Subject: VIBRATION FELT THROUGH FLOOR / SEAT / STEERING WHEEL AT APPROX. 25 - 30 MPH	Bulletin No: 03-003/16
	Last Issued: 08/11/2016

2013-2016 CX-5 vehicles equipped with automatic transmission

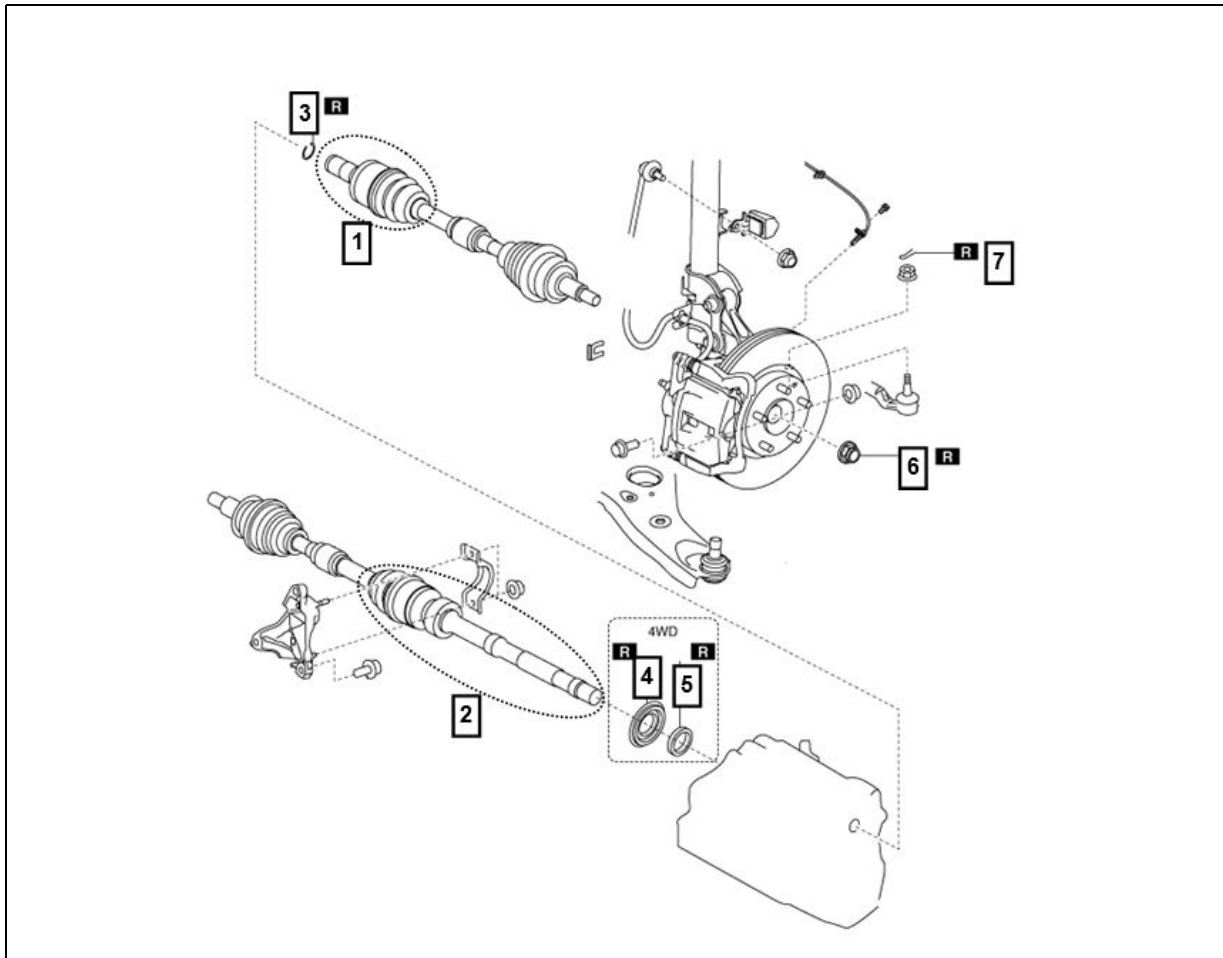
The vibration may be caused by wear on the inner surface of the tripod joint case (inner side of front drive shaft). To eliminate this concern, a coating has been applied to the inner surface of the tripod joint case to improve wear resistance.

1. Verify the customer concern.
2. Replace the inner joint set for the left and right drive shafts with modified service parts according to the instructions on MS3 online (FRONT DRIVE SHAFT REMOVAL/INSTALLATION) and (FRONT DRIVE SHAFT (TRIPOD JOINT) DISASSEMBLY/ASSEMBLY).
3. Verify the repair.
